EAST ANGLIA ONE NORTH

EAST ANGLIA TWO

SEAS Additional WR on Landfall Site and cable corridor route around Ness House Deadline 13 – 5 July 2021

INDEPENDENT HYDROGEOLOGICAL ASSESSMENT

Figure 5. Groundwater contours in the vicinity of Ness House well, June 2021

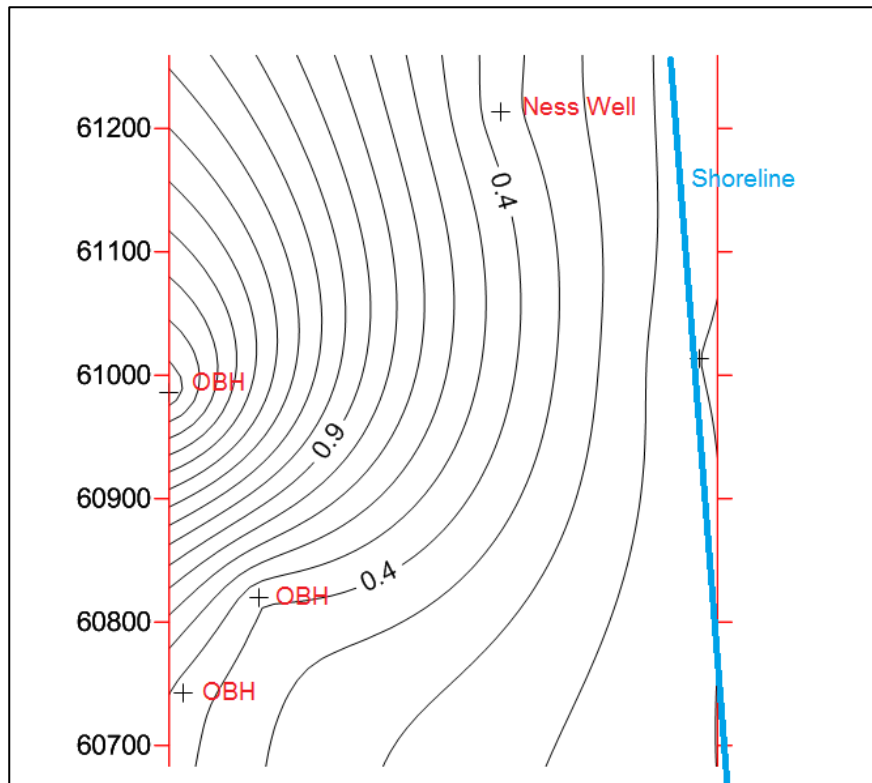
During the June 2021 site visit to the local area, groundwater levels in a number of observation boreholes, and the Ness House well itself, were measured. These have been used to generate groundwater contours (note groundwater levels are assumed to be 0 maOD at the shoreline). The rest water level in the Ness House well was recorded as 0.34 maOD (11.82 metres below ground level). Based on the contours, the general groundwater flow direction in the vicinity of the well is to the east, toward the shoreline.

Figure 6. Ness House well groundwater levels plotted against sea level

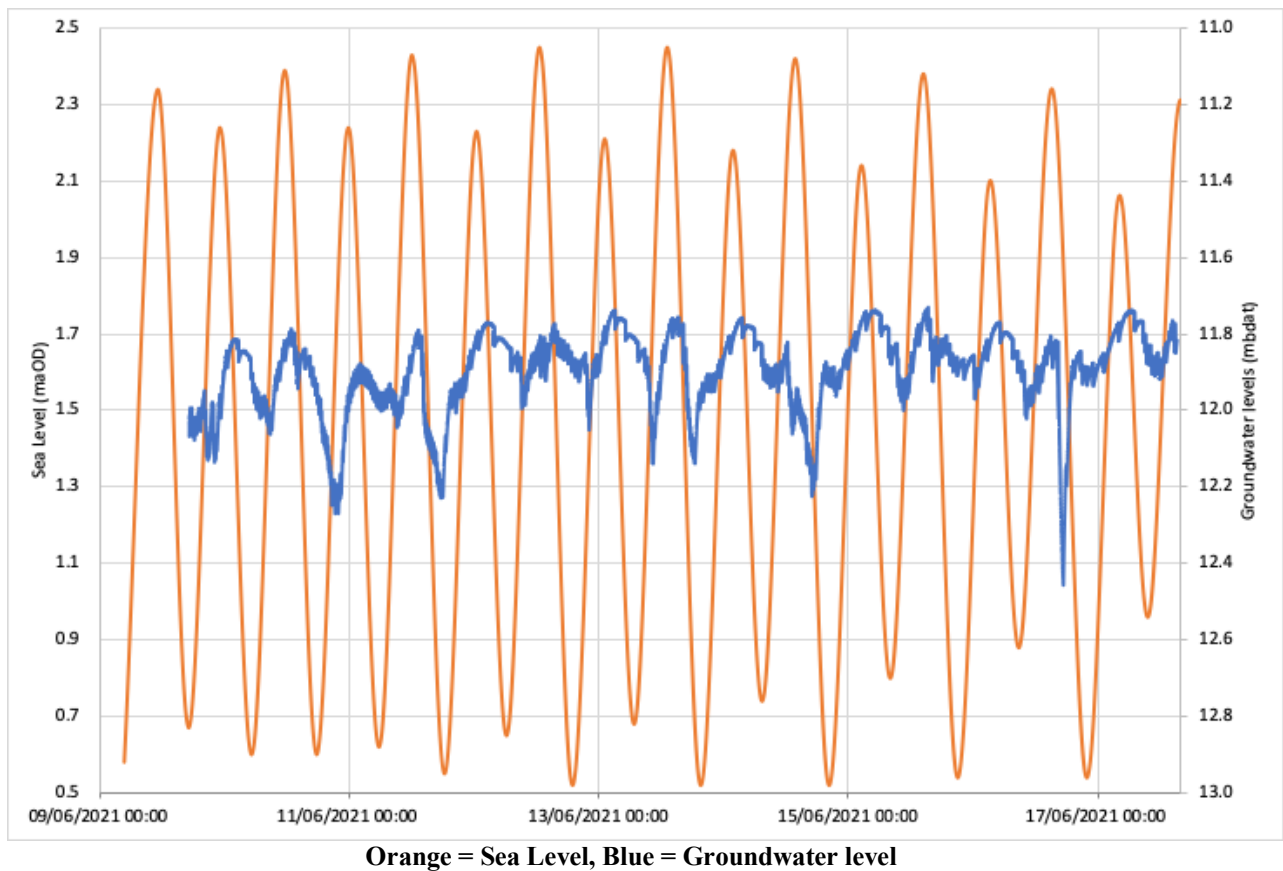
The fluctuation in groundwater levels as a result of tidal changes, approximately 150 metres inland from the line of low water [low tide level] shows the sensitivity of the well to activities some distance away. The directional drill site is 200 metres from the well at its closest point. It is therefore reasonable to conclude that there would likely be an influence on water levels, water quality and the availability of water to the well as a result of changes in/to the ground in the vicinity of the directional drill location.

Figure 9: Modelled particle traces

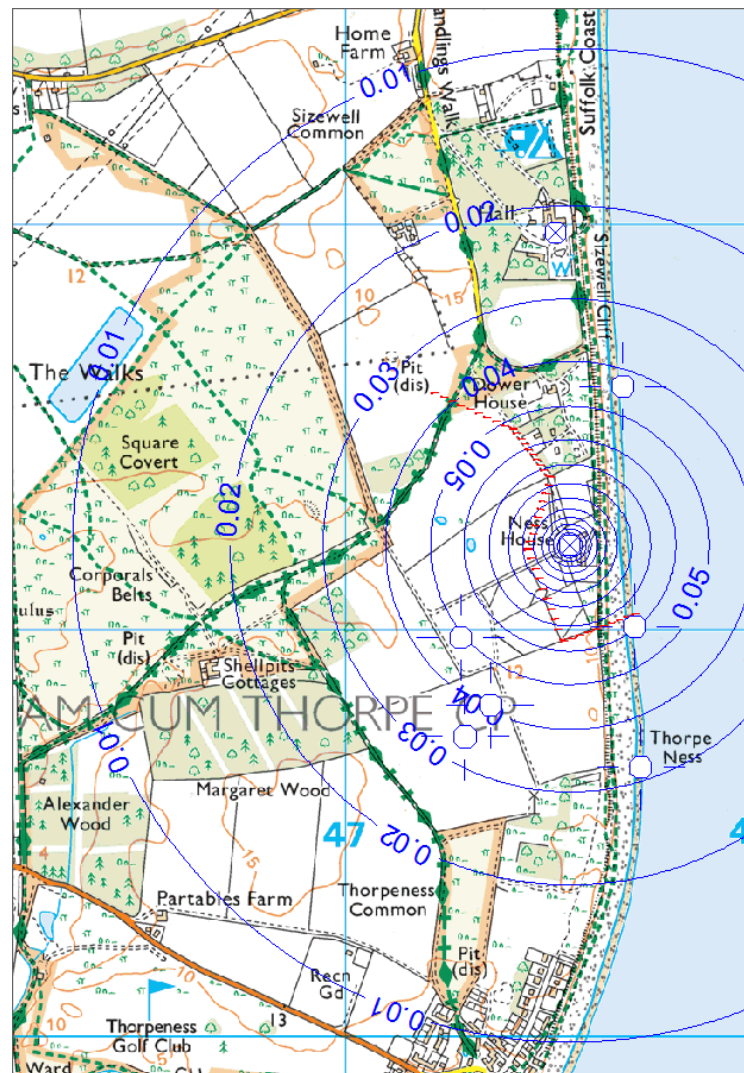
This output shows the Well would be vulnerable to disturbance to the ground along the line of the cables where it passes nearby and any contamination that may enter the ground. The model suggests there would be limited movement of groundwater from the directional drill location to the Well while there is free movement of groundwater in the aquifer. This model cannot, unfortunately, simulate what might happen if the directional drill was to result in an east-west barrier to groundwater flow. As the radius of drawdown is shown to extend to beyond the directional drill area, any change in the ground's ability to store and

transmit groundwater in that area will distort natural and abstraction induced groundwater flow directions. That would then result in a change in the source/recharge area that sustains the Ness House abstraction.
